**Reference: 750 Old Highway 24 – Site Plan Application – Phase 1 Submission 3
Verlinda Homes, Waterford, Norfolk County
Our Project 20-128**

G. Douglas Vallee Limited is the agent acting on behalf of Verlinda Homes regarding a site plan application with Norfolk County. Please accept this package as our formal third site plan application for a commercial / retail development located at 750 Old Highway 24 in Waterford.

H:\Projects\2020\20-128 Orchard Square\Agency\Submissions\2024.08.22 - Phase 1 - Site Plan - 2nd Submission\Phase 1 Submission 2 Cover Letter.docx

Drawing Title
GRADING PLAN

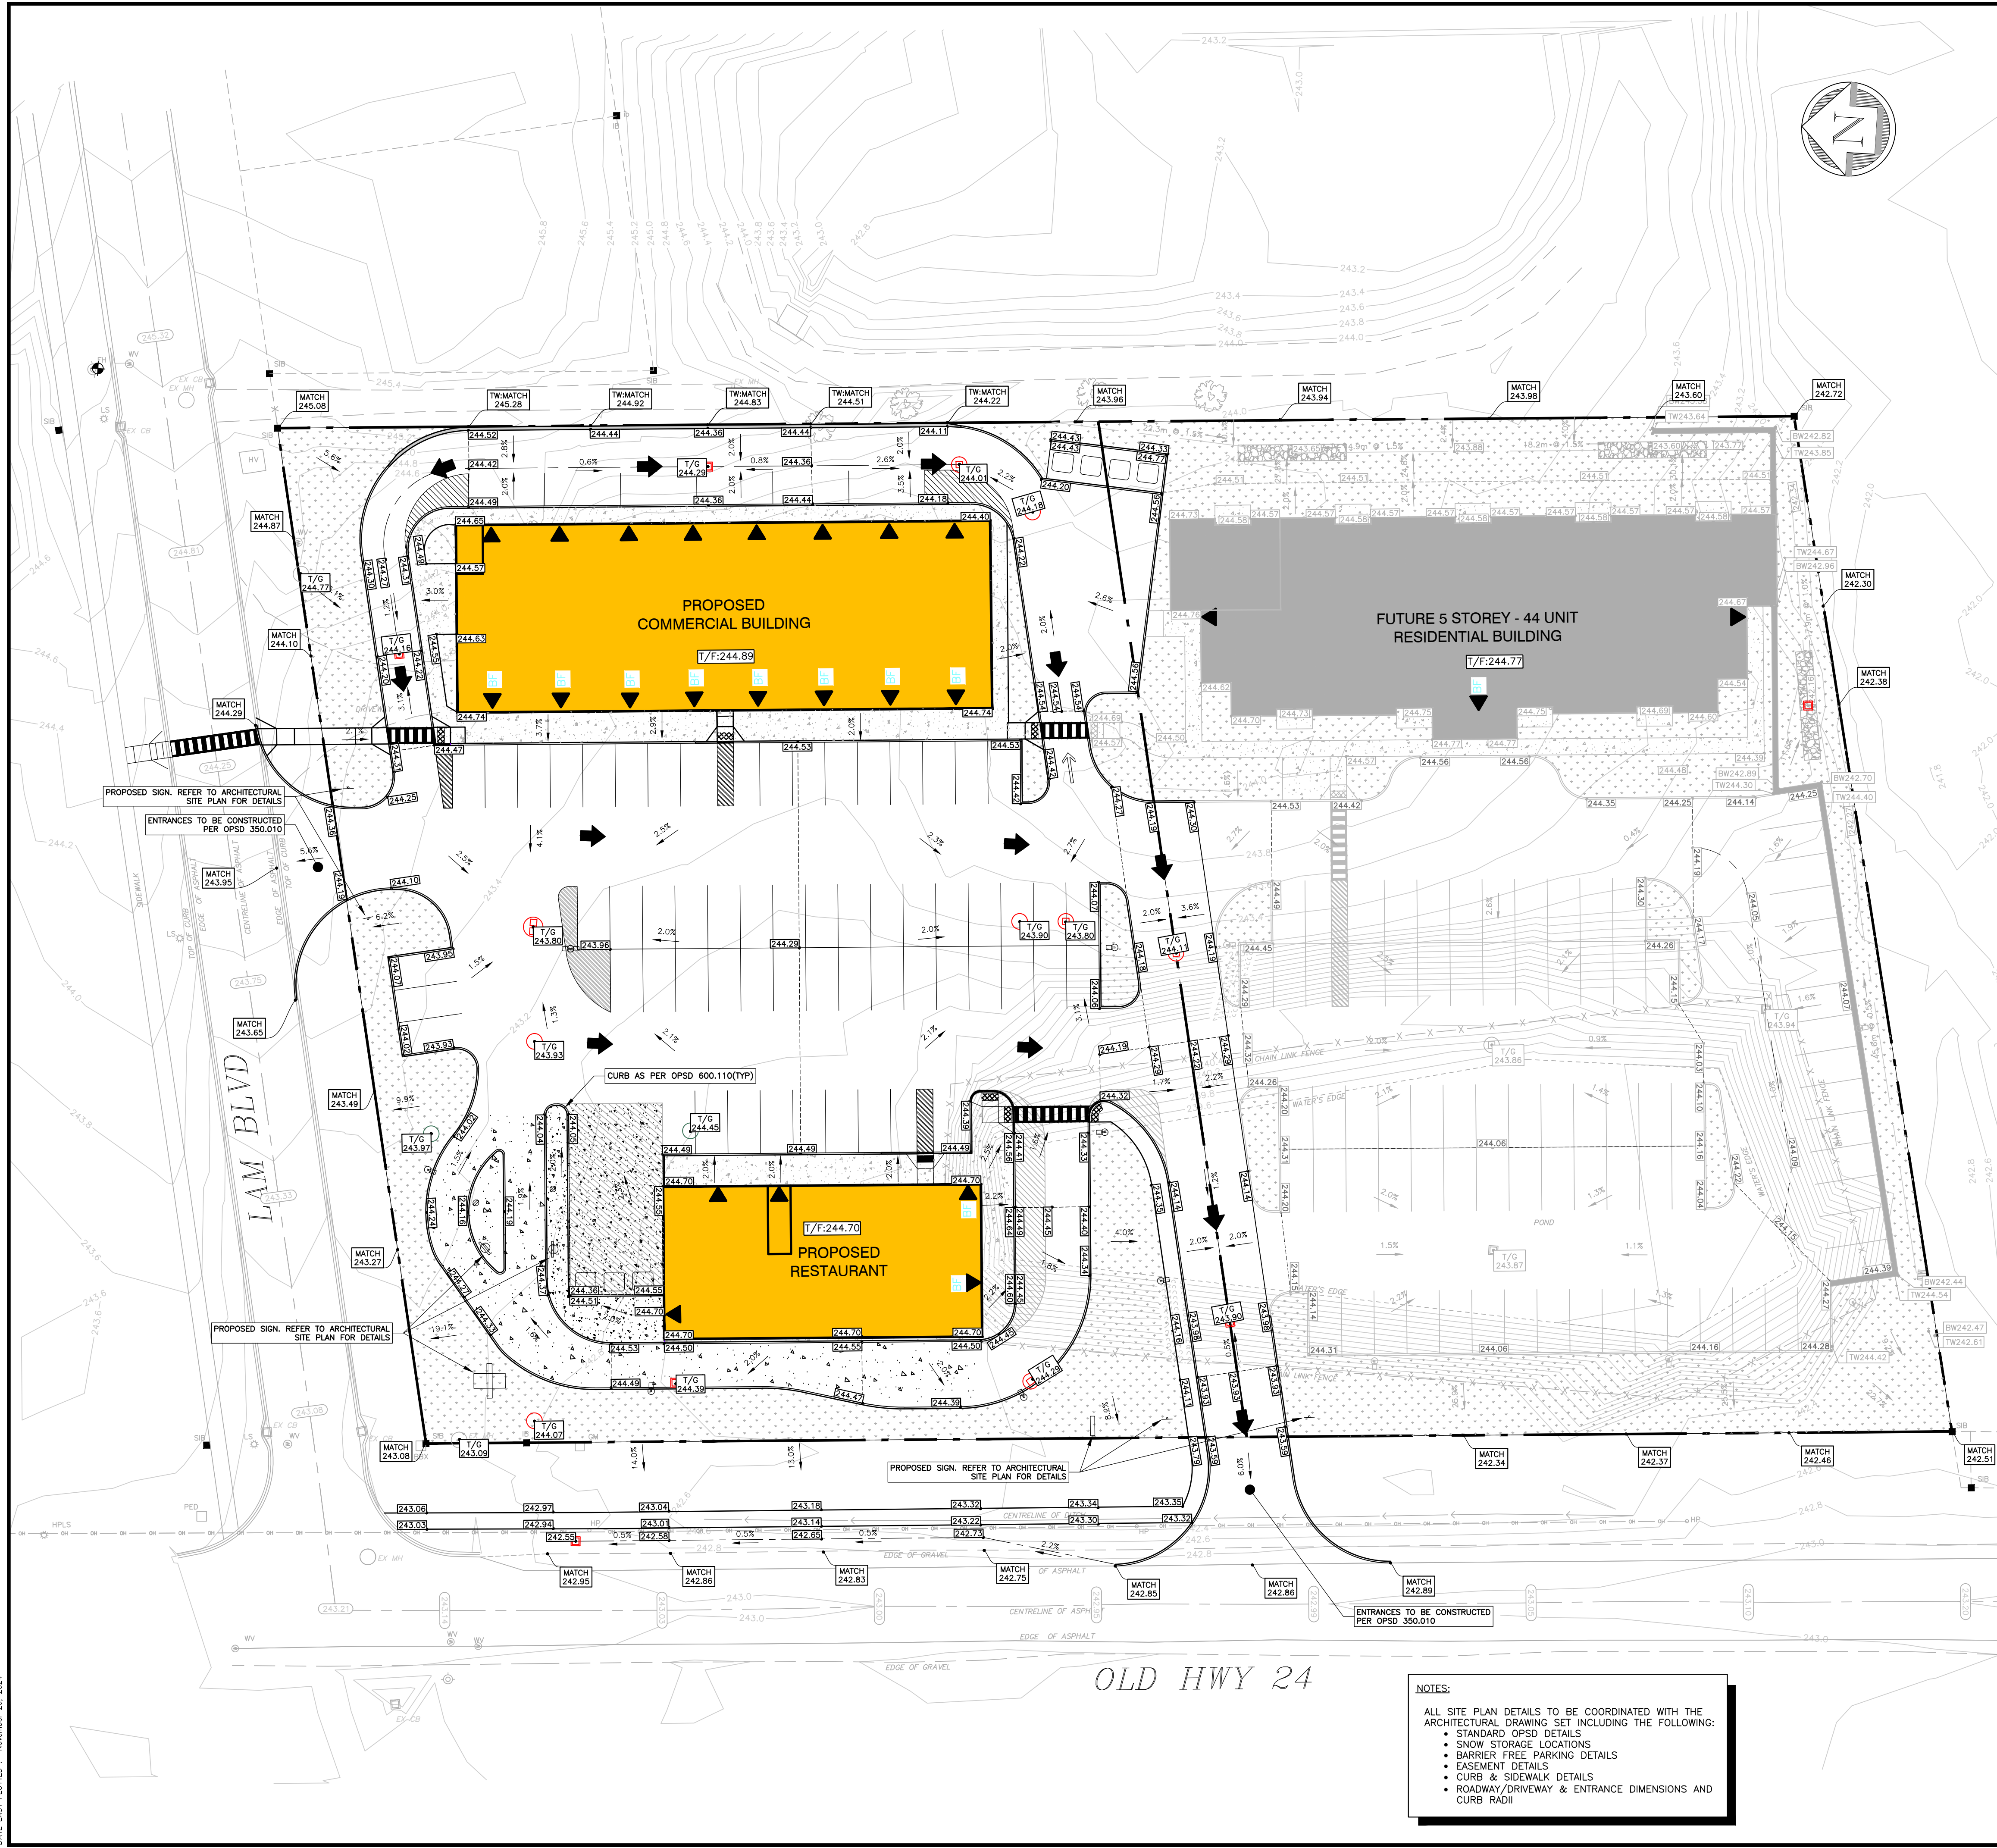
1st Submission	Development Engineering Grading Plan DWG 102	20	15-Jul-24	All manholes, catchbasins, sidewalks, parking space line painting, etc. to be labelled or shown in legend with existing or proposed identification (labels, line types, etc.).	All manholes, catchbasins, valves and curb stops are labeled on C101. All sidewalks, parking space line painting, etc are shown on Drawing A101B Site Plan and A102 Site Plan Details.	16-Oct-24	Addressed.		Vallee - Architecture	Complete
1st Submission	Development Engineering Grading Plan DWG 102	21	15-Jul-24	In the plan, provide the arrow in the legend depicting emergency overland flow direction. Please show Emergency Overland Flow directions.	Noted. Emergency overland flow direction arrows have been added to the plan.	16-Oct-24	Addressed.		Vallee - Civil	Complete
1st Submission	Development Engineering Grading Plan DWG 102	22	15-Jul-24	Specify and label tactile plates where needed.	Coordinate with drawing A101B Site Plan.	16-Oct-24	Addressed.		Vallee - Architecture	Complete

1st Submission	Development Engineering Grading Plan DWG 102	23	15-Jul-24	At the entrances, provide grade break elevations and slopes as per 16.5.01. Also, provide elevations of the existing edge of asphalt.	Noted. Elevations and slopes are shown at all entrances, including the existing edge of asphalt elevation.	16-Oct-24	Addressed.		Vallee - Architecture	Complete
1st Submission	Development Engineering Grading Plan DWG 102	24	15-Jul-24	Add elevations for top grade of proposed sanitary manholes.	Noted. Top of casting elevations have been shown on all sanitary manholes.	16-Oct-24	Addressed.		Vallee - Civil	Complete
1st Submission	Development Engineering Grading Plan DWG 102	25	15-Jul-24	Add OPSD standards for curb and sidewalk. Similar to what is shown on Arch drawings or just reference them.	Coordinate with drawing A105 and A105A OPSD Details.	16-Oct-24	Comment not addressed.	All curb and sidewalk details/OPSD standards are shown on Drawing A105 and A105A. They will not be duplicated on other plans to avoid cluttering the drawings. Drawing C102 Grading Plan notes that curb and sidewalk details are shown on the architectural drawings.	Vallee - Architecture	Complete

1st Submission	Development Engineering Grading Plan DWG 102	26	15-Jul-24	An area rough grading plan is required as the earth fill exceeds 0.5m as per 11.6.01.	Noted. An excess cut and fill drawing has been created.	16-Oct-24	Addressed.		Vallee - Civil	Complete
1st Submission	Development Engineering Grading Plan DWG 102	27	15-Jul-24	The existing ground contour to be extended 30m beyond the property limits to indicate the grading and drainage pattern of the adjacent land as per 16.4.02.	Noted. The viewport has been extended to show contours 30m beyond the property limits.	16-Oct-24	Addressed.		Vallee - Civil	Complete
1st Submission	Development Engineering Grading Plan DWG 102	28	15-Jul-24	Add roadway/driveway dimensions and curb radii.	Coordinate with drawing A101B Site Plan.	16-Oct-24	Comment not addressed.	All roadway/driveway dimensions and curb radii details are shown on Drawing A101B. They will not be duplicated on other plans to avoid cluttering the drawings. Drawing C102 Grading Plan notes that roadway/driveway dimensions and curb radii details are shown on the architectural drawings.	Vallee - Architecture	Complete

1st Submission	Development Engineering Grading Plan DWG 102	29	15-Jul-24	Show existing elevations at centerlines of Old Highway24 and Lam Boulevard at 20m intervals as per 16.4.02.	Noted. Existing road centreline elevations have been added.	16-Oct-24	Addressed.		Vallee - Civil	Complete
1st Submission	Development Engineering Grading Plan DWG 102	30	15-Jul-24	Where a retaining wall is 0.60m or higher, placement of fencing or a guard along the top of the wall is required as per 11.4.00.	A fence is proposed along the top of the retaining wall. Refer to drawing A101B Site Plan.	16-Oct-24	Addressed.		Vallee - Civil	Complete
1st Submission	Development Engineering Grading Plan DWG 102	31	15-Jul-24	Please add note that all entrances are to be constructed as per OPSD 350.010 or reference the ARCH drawings.	Coordinate with drawing A105A OPSD Details.	16-Oct-24	Comment not addressed.	Noted. Drawing C102 Grading Plan has been updated to note OPSD 350.010.	Vallee - Architecture	Complete

1st Submission	Development Engineering Grading Plan DWG 102	32	15-Jul-24	This plan shows filling of the ditch along Old HWY 24 to place the required sidewalk. Norfolk County is concerned the existing ditch is an outlet for upstream Strom water. A proper outlet must be identified as upstream storm water will not be permitted to flood onto old HWY 24.	Coordinate with drawing A101B Site Plan. There is a red note that the county is to confirm the location of future proposed sidewalk location. Note that the only water that enters this ditch is from the subject development site and from off Old Highway 24. No up stream storm water from other areas enter this ditch.	16-Oct-24	As with other similar comment responses, the contributing drainage area for this roadside ditch is unknown and must be delineated for further review.	Refer to comment 4 response.	Vallee - Civil	Complete
1st Submission	Development Engineering Grading Plan DWG 102	33	15-Jul-24	T/G CB5 is only 3cm lower than the high point in driveway before flows cascade onto Old HWY 24. Please adjust this lid to provide the minimum ponding levels to contain the Major storm events.	All storm sewers have been sized to convey the 100-year storm event, therefore no ponding will occur in major storm events. Refer to the storm design sheet on Drawing STM.	16-Oct-24	Please update SWM Report to refer to the correct ultimate drainage location (Ex. 300 storm sewer, not 600mm).	Noted. The SWM Report has been updated.	Vallee - Civil	Complete

1st Submission	Development Engineering Grading Plan DWG 102	34	15-Jul-24	Please show 100yr ponding levels in your next submission.	All storm sewers have been sized to convey the 100-year storm event, therefore no ponding will occur in major storm events. Refer to the storm design sheet on Drawing STM.	16-Oct-24	Pipe utilization is maximum 85% as an industry standard. Determine overall overland flow route external to the site plan application. Old Highway ROW SWM infrastructure is missing at the proposed drainage locaton at driveway entrance and subsequent ditch elevations. Direction of flow is unknown and there appears to be a DICB at the intersection Lam Blvd that may with the emergency overland flow route.	Norfolk County standards indicate that pipe capacities should not exceed 95% of full capacity (Section 7.8.07). The storm sewer design has been updated so that all pipes are equal to or less than 95% full. The existing DICB on the west side of Old Highway 24 at Lam Blvd is shown on Drawing C101 Servicing Plan and Drawing C102 Grading Plan. Refer to comment response 4 regarding the ditch drainage areas/concerns.	Vallee - Civil	Complete

1st Submission	Development Engineering Grading Plan DWG 102	35	15-Jul-24	Please note that grading for the future Residential building was not reviewed in detail for this submission. A couple of things to consider for the future development of that site are as follows: i. Revise the swale along the east limit of the property so that Min. slope allowed is 1.5% as per Norfolk County Design Criteria, Section 16.5.01.	Noted. The swale slope has been revised.	16-Oct-24	Addressed.		Vallee - Civil	Complete
1st Submission	Development Engineering Erosion & Sediment Control Plan DWG 103		15-Jul-24	No Comments.	No response required.	16-Oct-24			Vallee - Civil	Complete
1st Submission	Development Engineering Site Section Plan DWG 104	36	15-Jul-24	Norfolk County is unclear as to the purpose of this drawing? Was this drawing supposed to include a cross-section of the Underground Storage system. This would be a preferred addition to the drawings.	Yes, this drawing has been updated to present the underground storage system cross-section.	16-Oct-24	Outlet configuration (ie. 75mm orifice) and inlet and outlet STM sewer to be included in this corss-section.	The outlet configuration and inlet and outlet storm storm details are shown on Drawing C101 Servicing Plan. They will not be duplicated to avoid cluttering the plans.	Vallee - Civil	Complete

Drawing Title: **GENERAL NOTES**

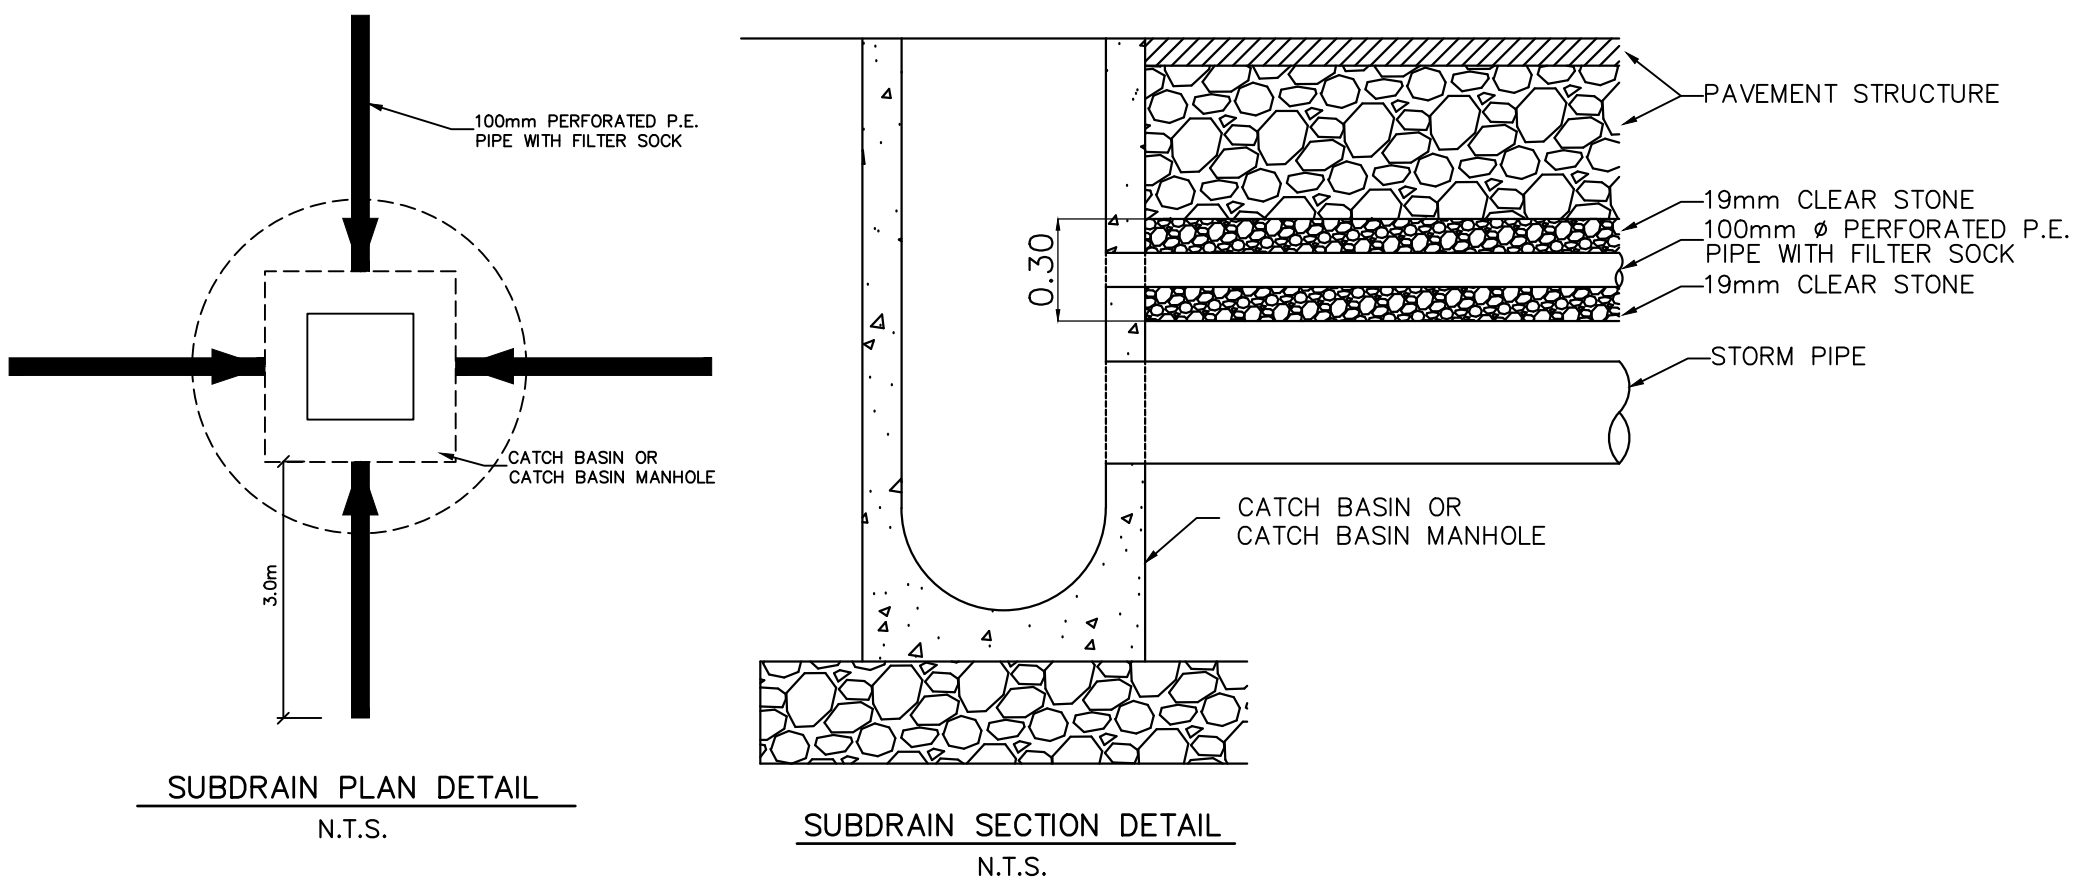
1st Submission	Development Engineering General Notes Plan DWG GN	41	15-Jul-24	The General Notes must include all references to the Sidewalk, Curb & Gutter and Entrance OPSD's as shown in the Arch drawings.	Coordinate with drawing A105A OPSD Details.	16-Oct-24	General Notes requires as an update per original comment.	Noted. Drawing GN General Notes has been updated to note that all sidewalk, curb, and entrance details are to be coordinated with the architectural drawings.	Vallee - Architecture	Complete
1st Submission	Development Engineering Sanitary Drainage Area DWG SAN	42	15-Jul-24	For the sanitary sewer design sheet, match the slope of the pipe from restaurant to SAMH1 to the slope shown in both C101 and SAN.	Noted. The sanitary design sheet has been updated.	16-Oct-24	Addressed.		Vallee - Civil	Complete
1st Submission	Development Engineering Storm Drainage Area DWG STM	43	15-Jul-24	It is recognized that the entire site is not self-contained as typically required by Norfolk County. In review it appears most of the area not contained are grass areas and generally small in nature. The County accepts this concept.	No response required.	16-Oct-24	Addressed.		Vallee - Civil	Complete
